TOWN OF ERIN COURT OF REVISION

TOWN OF ERIN COURT OF REVISION- OSPRINGE DRAIN- SUMMARY OF APPEALS

Ospringe Drainage Plan – Thomas Field Subdivision

Impact to Schotsch property located at 8947- Wellington Road 124/Lot 13-Concession 3

JAN 11-12 2020

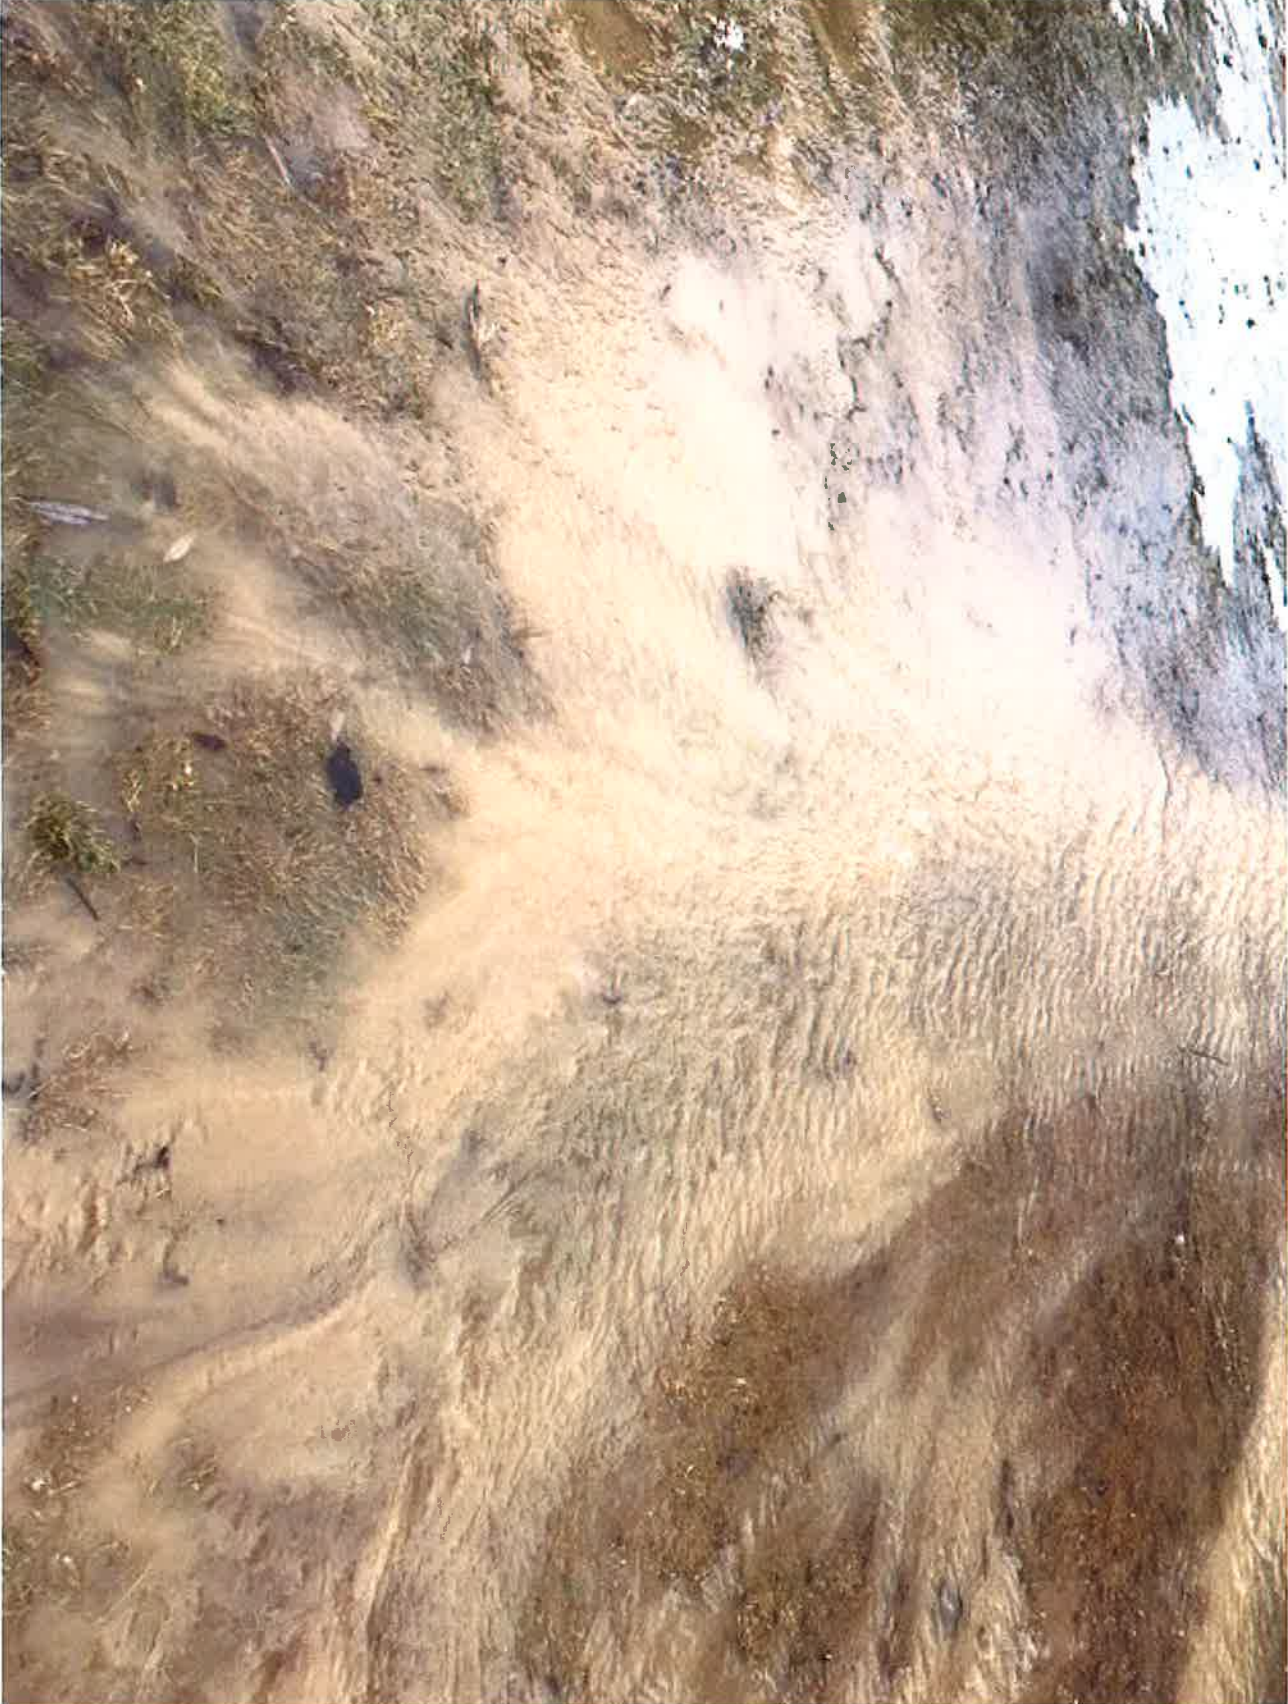
In early January 2020, 2 days of rain and runoff from Thomas Field Subdivision caused tremendous flooding, muddy water and silt on our lawn. This was like nothing we have experienced before. The water overflowed our small creek/back ditch covering 3 acres of field with at least 6" – 12" of water, overflowing our small footbridge, flooding a tool shed, encroaching on our firepit, making it impossible to utilize our property. Some of our large trees uprooted and many are in danger of falling due to erosion. The water flow was so rapid that you could have kayaked – we have videos. Our septic system may only be 12-18" above the high flood mark that we witnessed. This is the first winter since 1968 where the small creek/back ditch has not frozen, most winters it is completely empty or may have 2-3 inches of frozen ice.

Measurement of this flood shows that the suggested 2 drainpipes (60 cm diameter each) provided in the Drainage plan will only allow 1/3 of the water volume to flow. The rest of the water would overflow onto our lawn, the field and the forest.

At 65% water flow (as last flood in Jan 2020) our neighbours was 1.30 m^2 and with us on the downside would require 4 – 5 60 cm culverts to manage the water flow or 2-3 larger culverts. These small culverts suggested in the proposal seem to be completely inadequate based on our findings.
